From: DIO ODC-IPS SG2a ,
Sent: 12 September 2014 11:06
To:
Subject: Re easo-authorized: Hill of Lychrobbie wind turbines
Attachments: 20140912 ADATS report redacted.doc; 20140912 Burn of Whilk assessment.doc

Title: WR80026/01
DIO 19464 – AIR TRAFFIC CONTROL (ATC)
RADARS – ASSESSMENT OF THE DEVELOPERS
PROPOSAL TO ESTABLISH A WINDFARM AT
HILL OF LYCHROBBIE, NEAR DUNBEATH,
HIGHLANDS

20131129-DIO19464 Concerns Hill of Lychrobbie-RSP1b-U

Figure 2

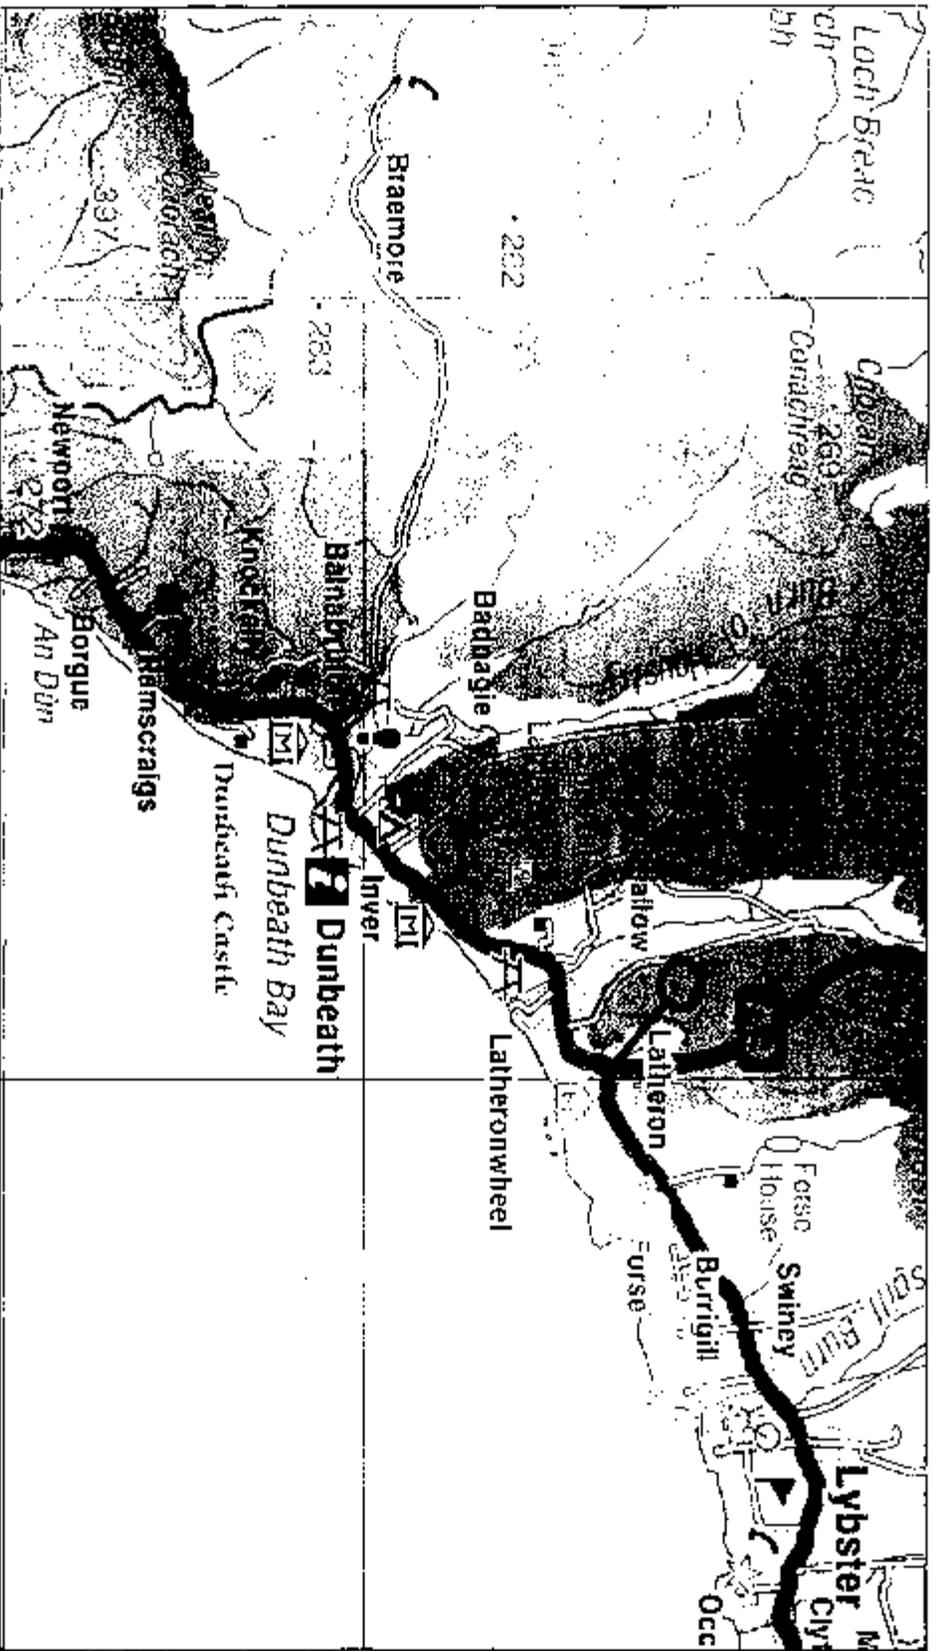
4.1.2 A Field Strength Coverage plot was generated for the radar using these parameters (Figure 2), indicating that all of the turbines will be detected by the radar.

It is recommended that the Operations Staff check whether the proposed wind farm at Hill of Lychrobbie is in an area of vital air traffic operations controlled by the radar at RAF Lossiemouth. If so a decision to object to the proposal should be considered on the grounds referred to in paragraph 3.1 and paragraph 3.2.
